STAFF REPORT
COMMUNITY DEVELOPMENT DEPARTMENT

SUBJECT: H-2022-0073 – Meridian OZ
Apartments – MDA, CUP

LOCATION: 1475 E. Franklin Rd., in the NE 1/4 of
Section 18, T.3N., R.1E. (Parcel
#S1118110051)

STREET PERSPECTIVE

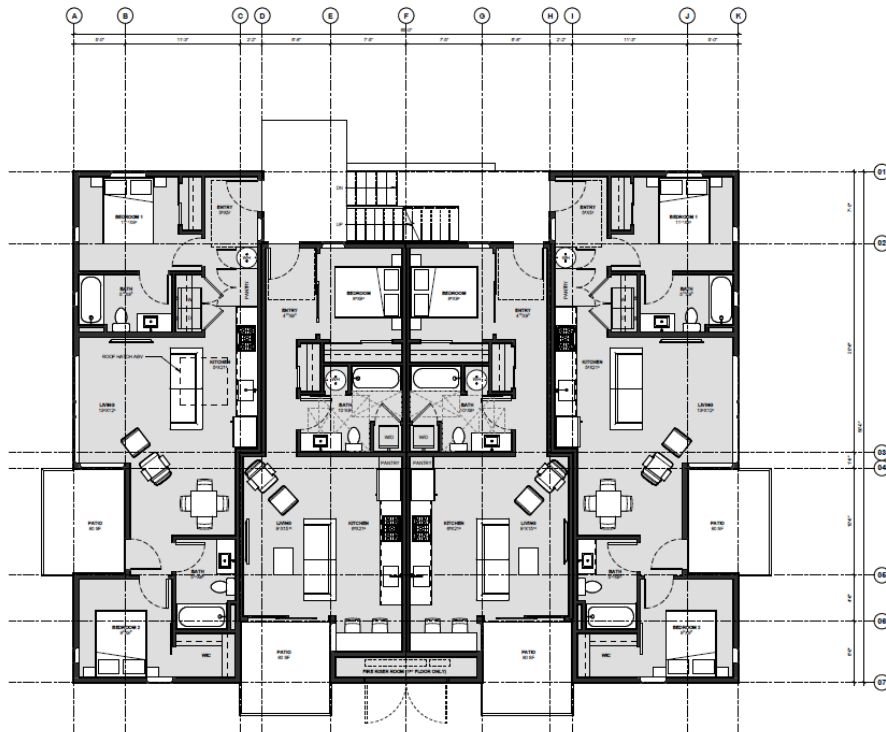
Building Elevations (UDC [11-3A-19](#) | [Architectural Standards Manual](#)): Conceptual building elevations and perspectives were submitted for the proposed 3-story structures as shown in Section VIII.E. Building materials consist of fiber cement panels between windows, stucco and synthetic wood cladding in neutral

colors. **Final design of all structures is required to comply with the design standards in the Architectural Standards Manual.**

7. All structures shall comply with the design standards listed in the Architectural Standards Manual.
8. The site and/or landscape plan submitted with the Certificate of Zoning Compliance shall be revised as follows:
